## SERVICE BULLETIN MAINTENANCE OF WAY EQUIPMENT

**DATE:** 10-5-2010 **BULLETIN NO:** 10-010

**TITLE:** CRUSHED JUPITER NETWORK CABLE

**PRODUCT SERIES / MODEL:** 6700S Tampers

FIGURE 1  
NETWORK CABLE SUSPECTED

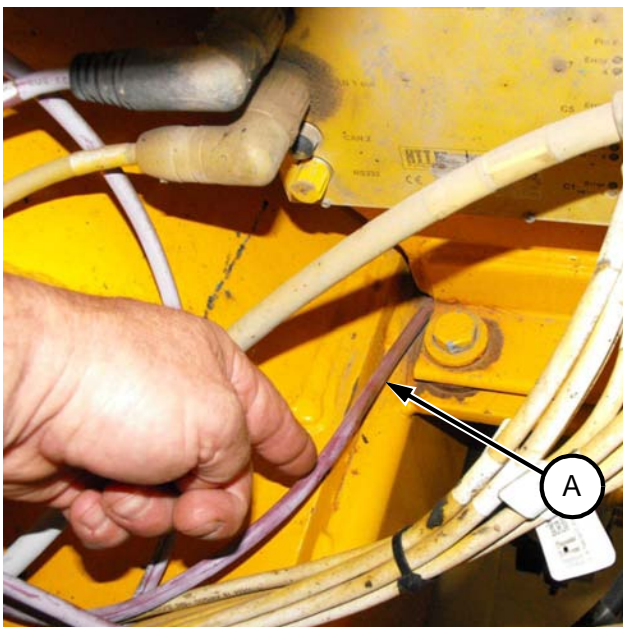
1. The Jupiter network cable (A) that needs to be inspected is NET08-09 which is the purple cable going from CAN08 mounted on the engine shroud to CAN09 mounted on the fuel tank. This cable runs between the fuel tank and the frame of the machine.

2. It is possible that this cable can slip down between the fuel tank and the frame and get pinched. With the action of the fuel tank while the machine is working, the cable can be crushed. If this crushing is severe, it could cause conductors inside the cable to short together and cause Jupiter network issues.

3. Disconnect the cable from CAN09 and pull it out for inspection. If there is evidence of crushing anywhere along the cable, it should be replaced.
4. When re-installing the existing (A) or new cable (5), route and secure the cable using the two cable clips (1), screws (2), lock washers (3) and flat washers (4) as shown, to prevent the cable from sliding down between the fuel tank and frame. It will be necessary to drill two pilot holes in the machine frame to install the two #10 mounting screws (2).
